Submission made by Jim Hurley via email on 4 May 2021 to the Foreshore Unit, Department of Housing, Local Government and Heritage (foreshore@housing.gov.ie) regarding Wexford County Council's application for a foreshore lease and licence for a proposed slipway at Fethard Harbour, Co Wexford (<https://www.gov.ie/en/foreshore-notice/4079e-wexford-county-council-fethard-slipway/>).

Figure 1. Access to Fethard Harbour via Quay Road.

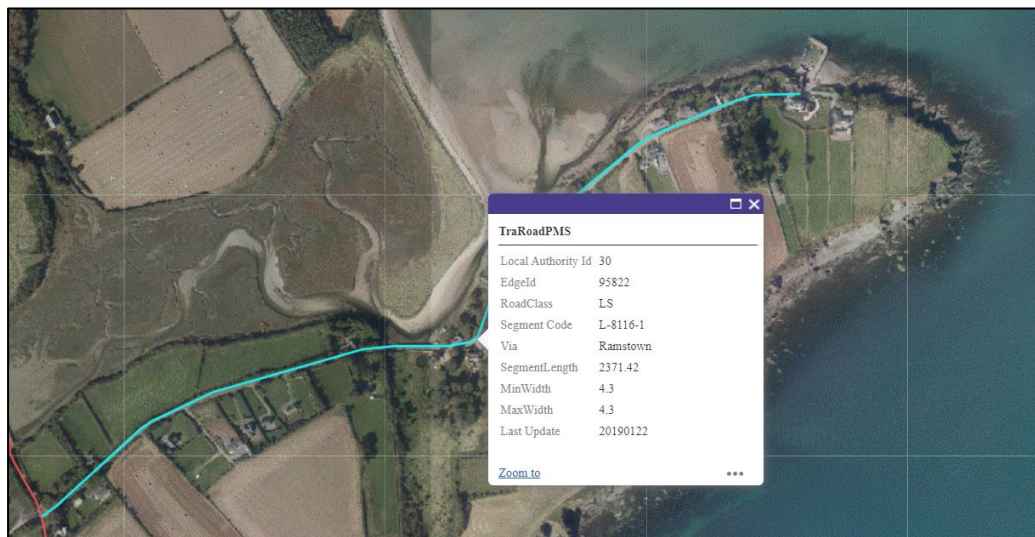
3. There are no boat-storage yards or facilities at Fethard Harbour. Consequently, any vessel being brought ashore via the proposed new slipway would have to be removed from the area. Similarly, any vessel being launched from the proposed new slipway would have to be brought into the area via the public roads network.
4. Fethard Harbour is located at the end of a narrow, 2.4km-long cul-de-sac. That third-class local road, known locally as 'Quay Road', is 4.3m wide (Figure 1). As a result, boat-transporting trailers wider than 4m cannot access Fethard Harbour.

Figure 2. Affected area for the foreshore lease application.

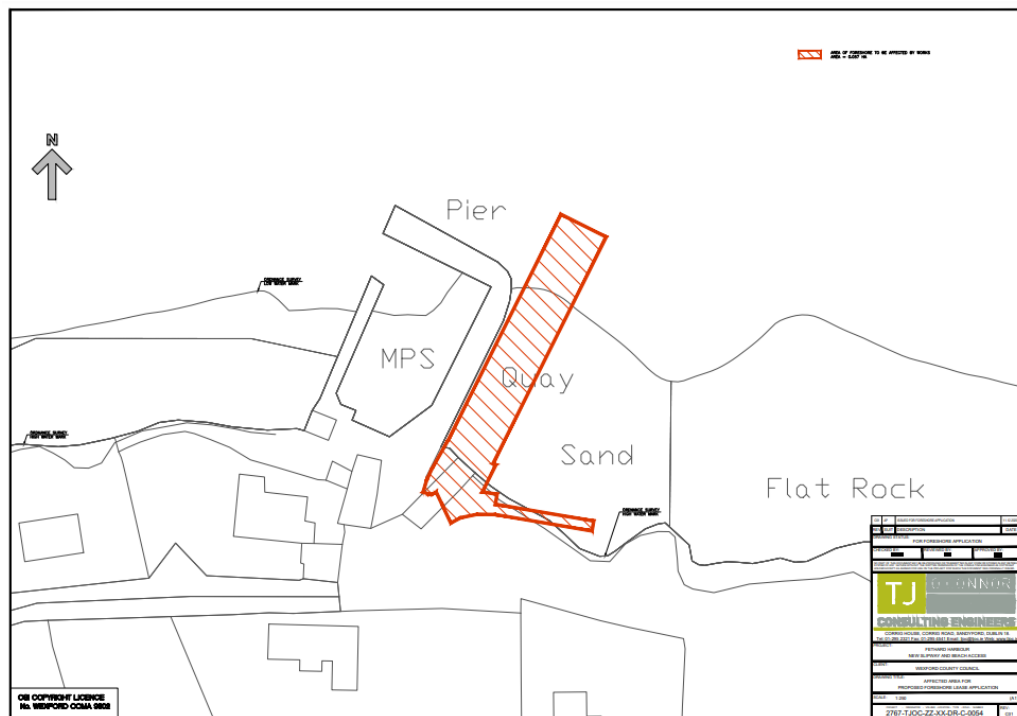
6. It follows, therefore, that a 10m-wide slipway is excessive to accommodate loads of maximum width 4m as determined by the width of the approach road. The size and scale of the proposed development is also out of kilter with the existing infrastructure (Figure 2 and Plate 1).

7. Reducing the width of the proposed new slipway from 10m to 5m would provide the required facility, and would, in addition, in my view, have significant benefits in that it would halve the presently proposed land take of some 0.057 hectares of foreshore from the protected area: Hook Head Special Area of Conservation (SAC No IE000764) (Figure 3), and Hook Head Marine Protected Area (MPA), it would increase the area of sand available for beachgoers, it would be less visually intrusive, and it would be more in keeping with the size and scale of the existing harbour infrastructure (Plate 5).
